**Addendum No. 2  
January 19, 2024**

Project: **Lennox High School Addition**  
Lennox, South Dakota  
Architecture Incorporated Project No.: 2982

Architect: Architecture Incorporated

**3.21-G**

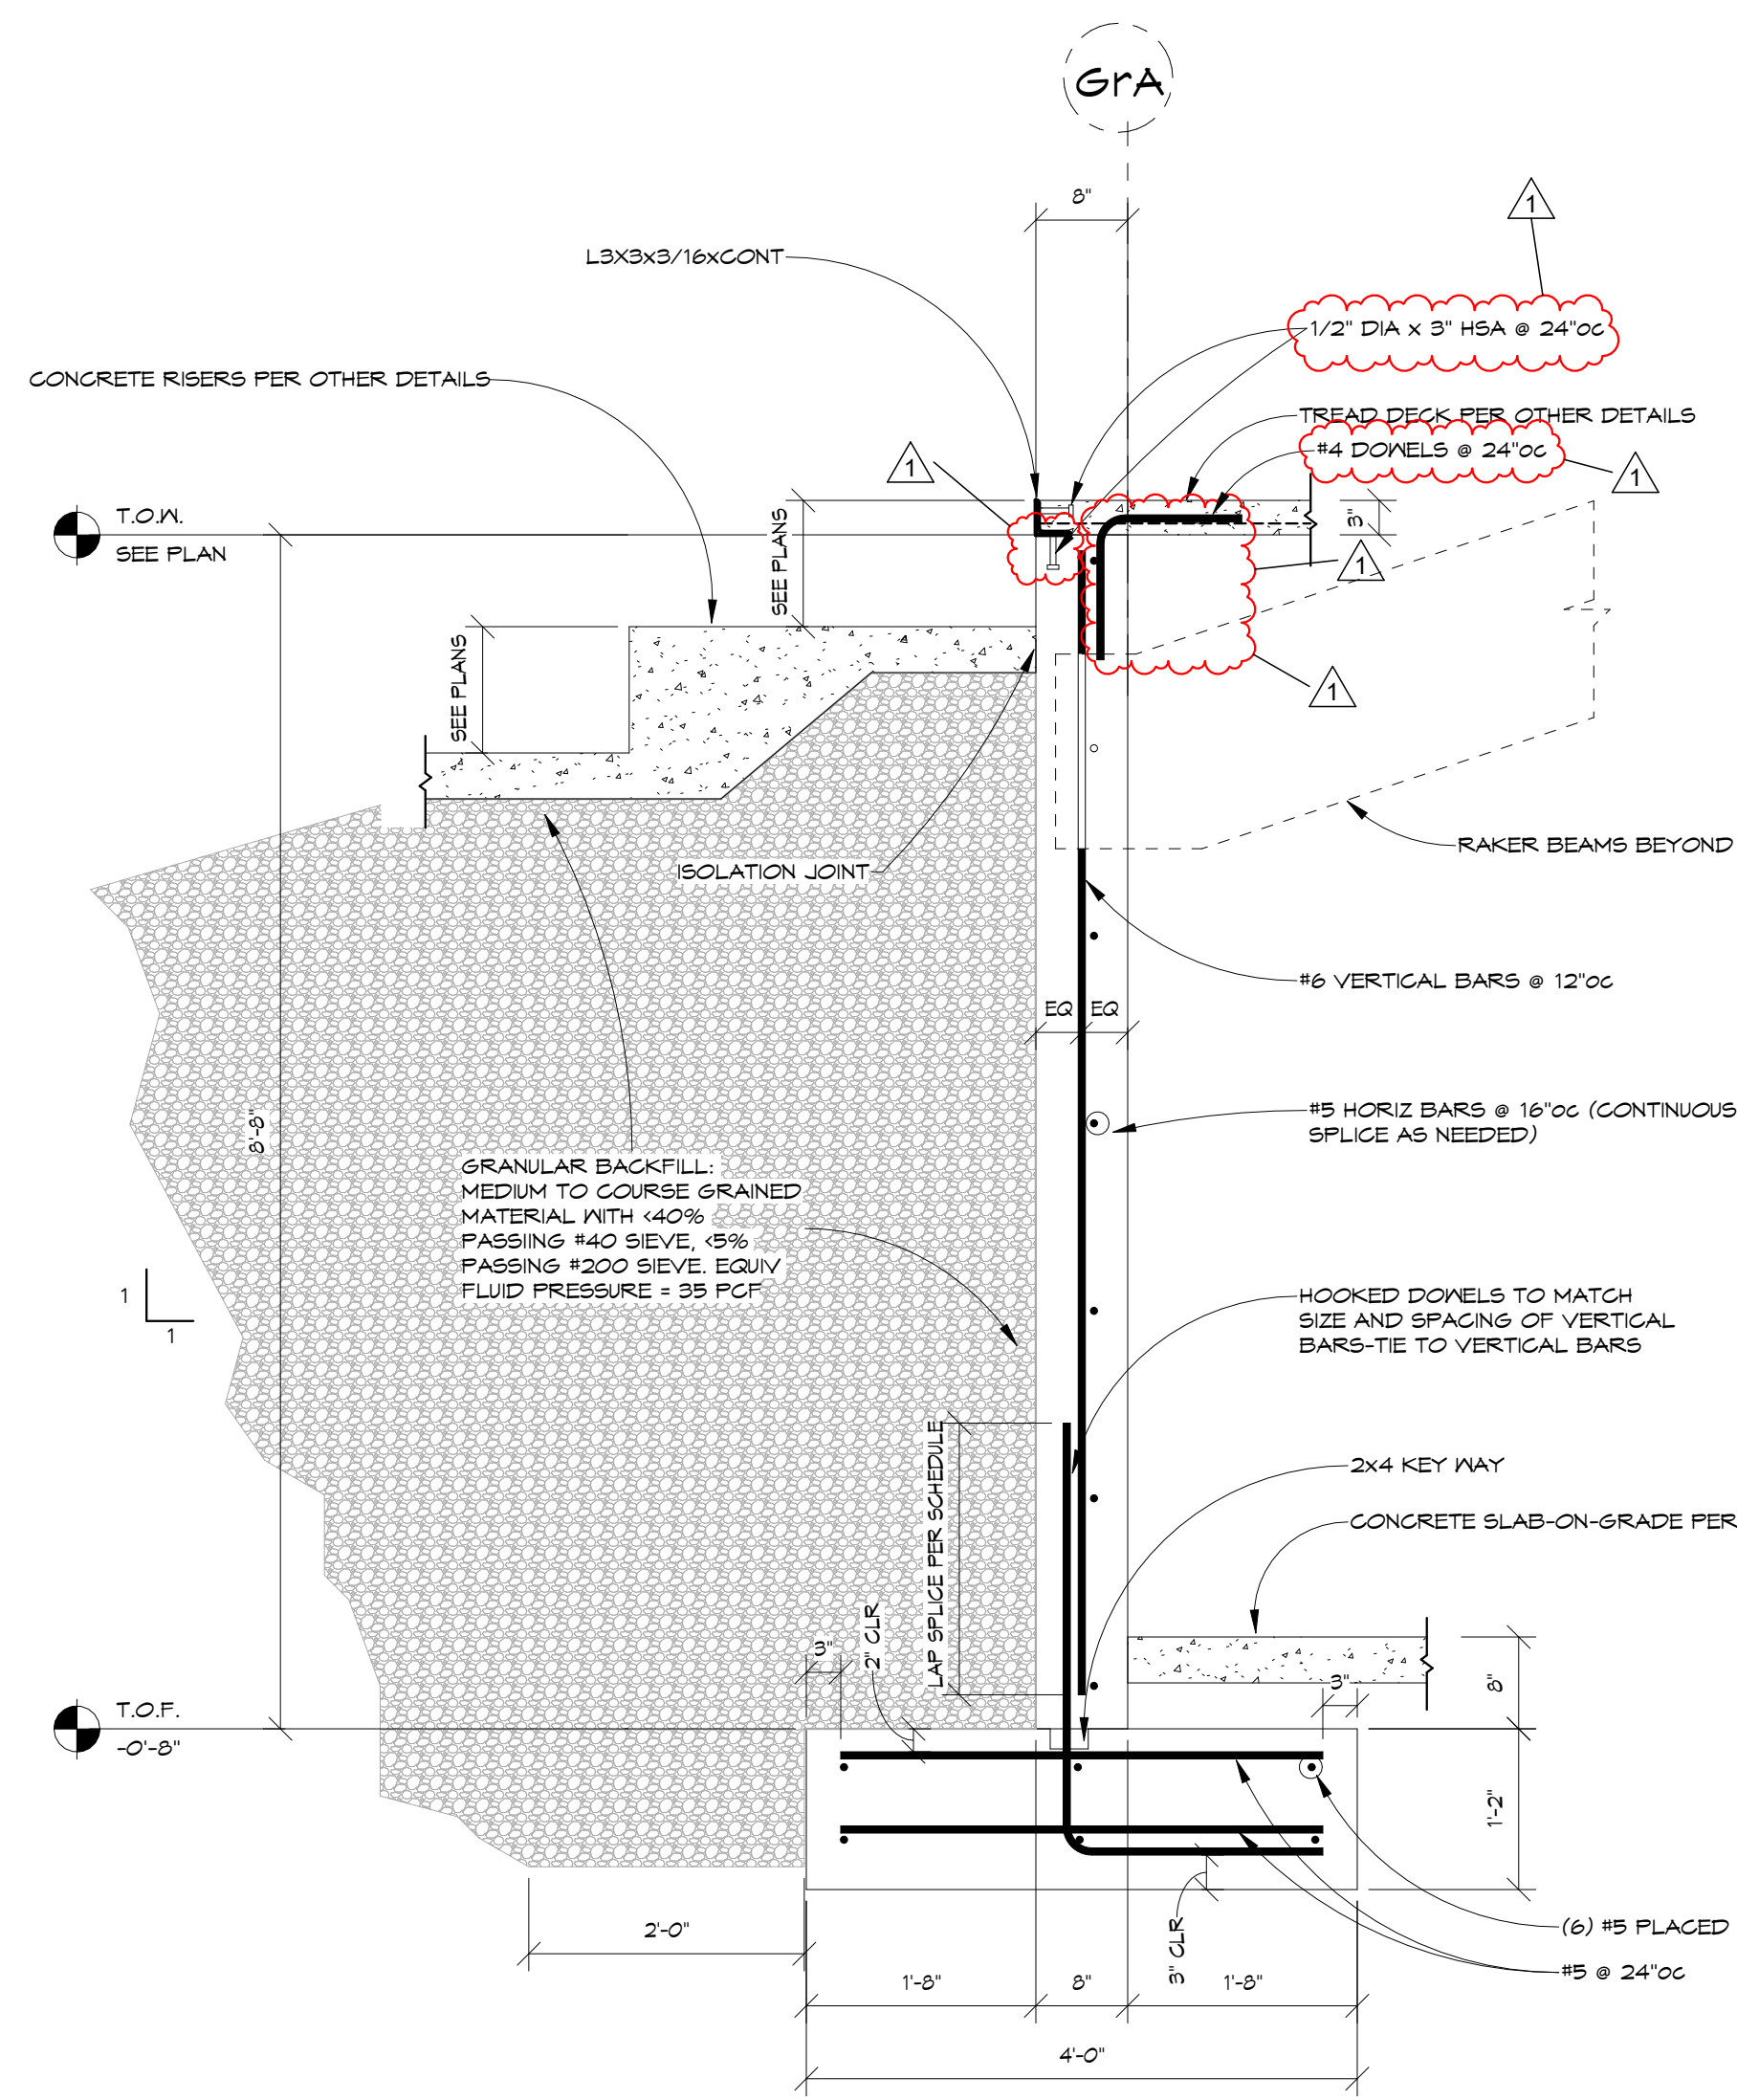
- a) Reference revised structural drawing Sheet 3.21-G, revision dated 1-18-24, attached to the end of this addendum for the following:

- i. Change detail reference of 17/3.51 (cut along the edge of the north and south mezzanine floor) to detail 22/3.51.
- ii. Add beam size tag along gridline G4 between grids GA and GC per the clouded revision on the attached revised sheet.

- iii. Change detail reference of 17/3.51 cut along the west edge of the mezzanine floor to 4/3.50 as shown within the clouded revision on the attached revised sheet.

- iv. Add reference detail 4/3.50 SIM to north and south ends of raker framing to precast walls per the clouded revision on the attached revised sheet.

3.51

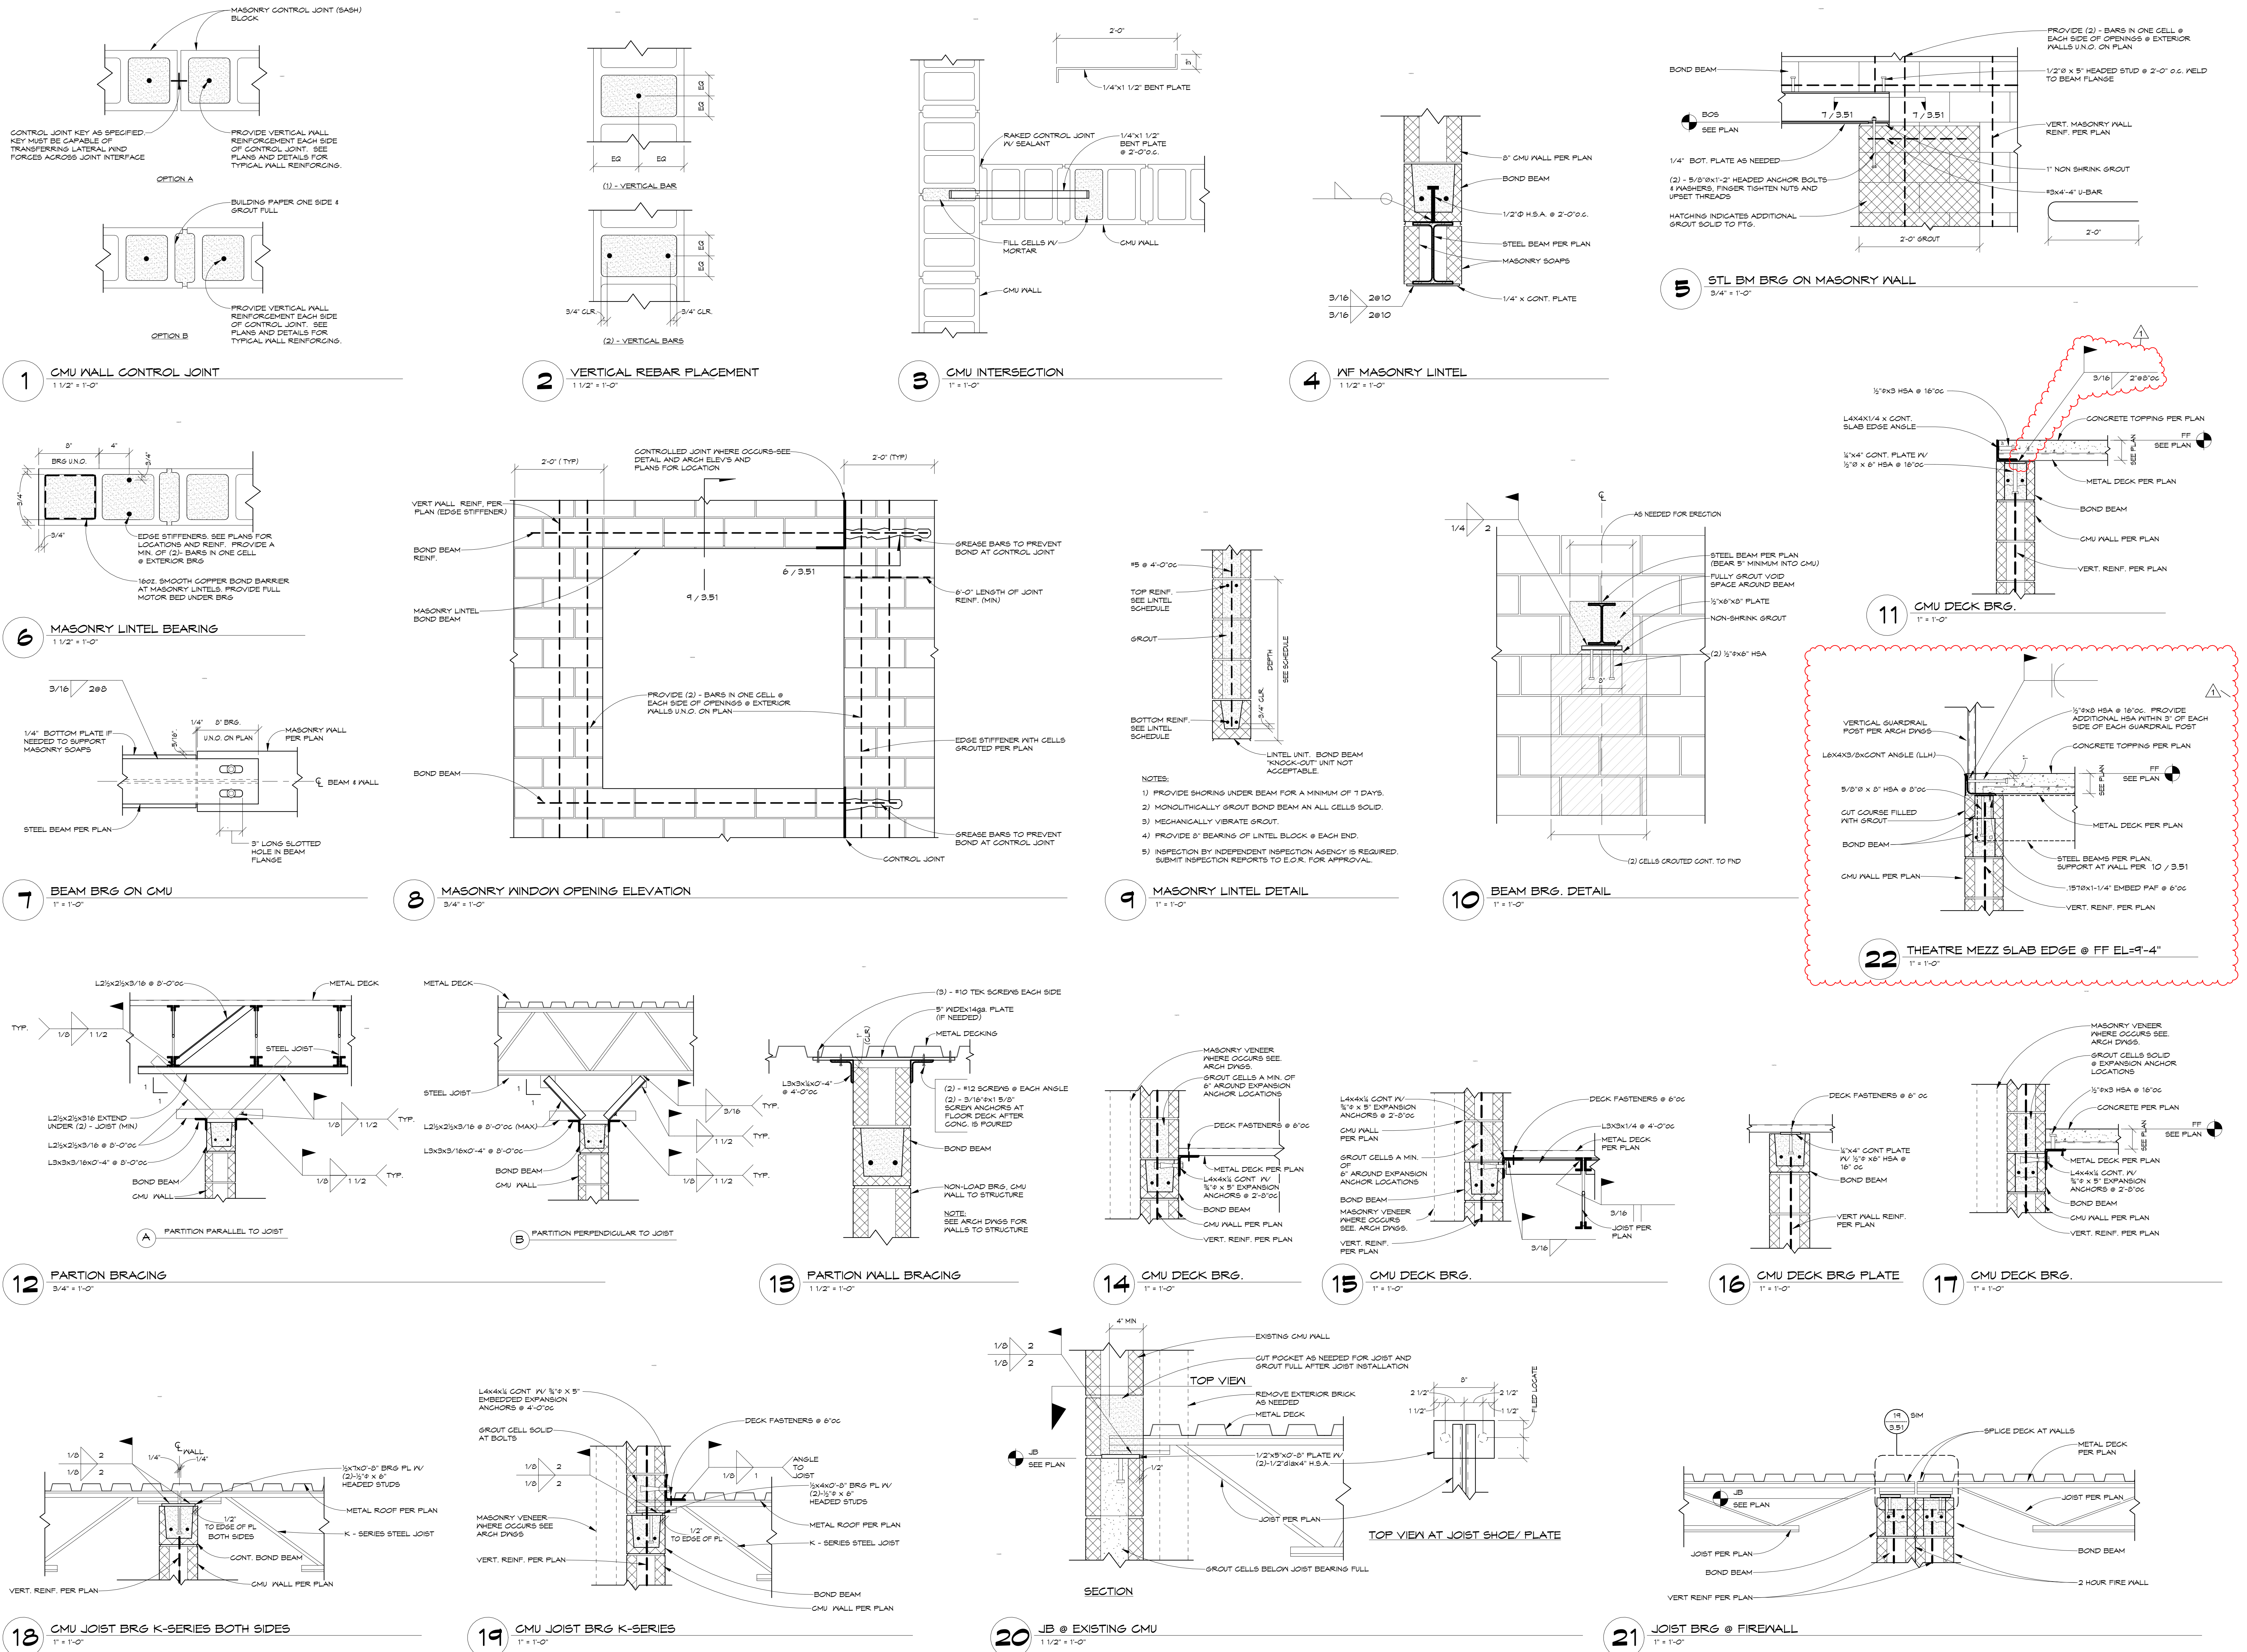
- 14) SHEET 3.51 - DETAILS - MASONRY
  - a) Reference revised structural drawing Sheet 3.51, revision dated 1-18-24, attached to the end of this addendum for the following:

- i. Detail 11: Add 3/16”x2” long fillet weld between the ¼”x4” CONT. PLATE and the L4x4x4x1/4.
    - ii. Add detail 22.
  - b) CLARIFICATION: Detail 20 - Follow general framing notes for deck edge support.
